RE: Lot 4 Block 4, Volcano Cliffs, Unit 18, SAD 228 6608 Papagayo NW

Grading and Drainage Plan Engineers Stamp Date 8/5/19 (D10D003J4)

Based upon the information provided in your submittal received 8/5/19, this plan is approved for Grading Permit.

LOT 4 BLK 4 UNIT 18 VOLCANO CLIFFS
6608 PAPAGAYO ROAD N.W.
GRADING AND
DRAINAGE PLAN

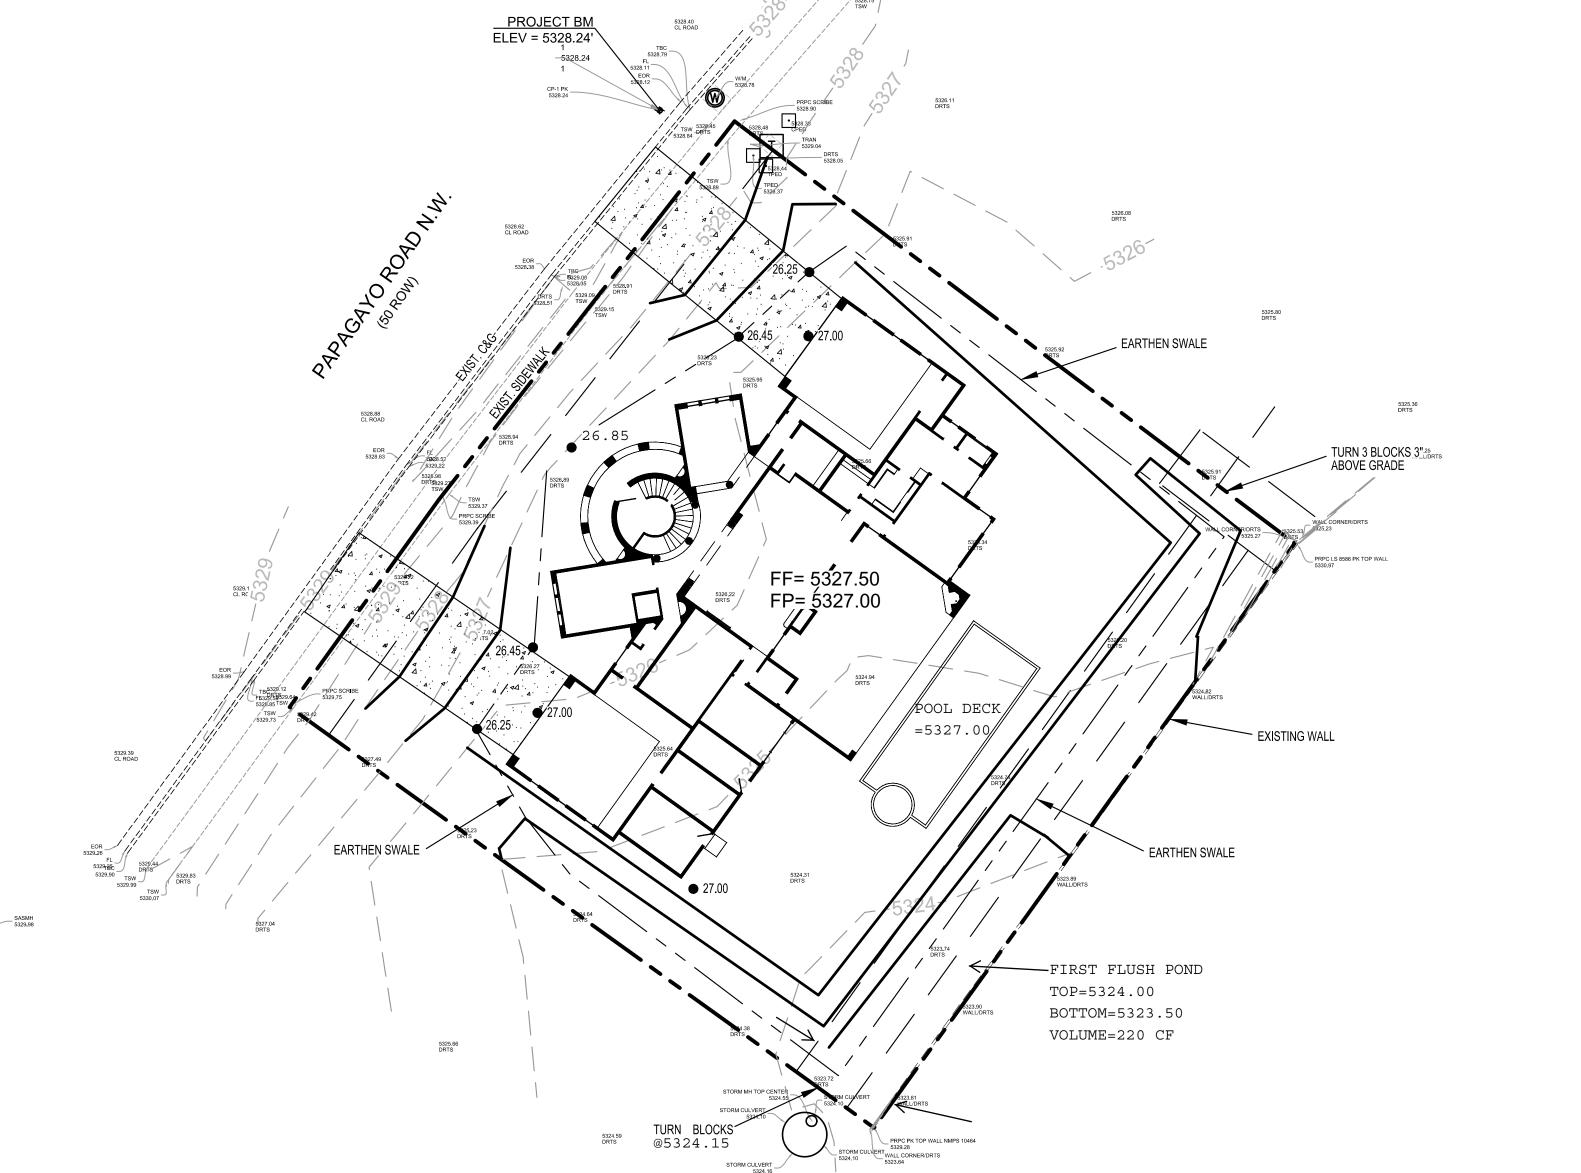
Prior to Building permit approval a Pad Certification will be required, provided by the Engineer or a registered Land Surveyor.

Reiterate to the Owner/Contractor that a separate permit for a garden/retaining wall must be obtained with the approved G&D plan and Pad Certification.

Prior to Certificate of Occupancy release, Engineer Certification per the DPM checklist is required.
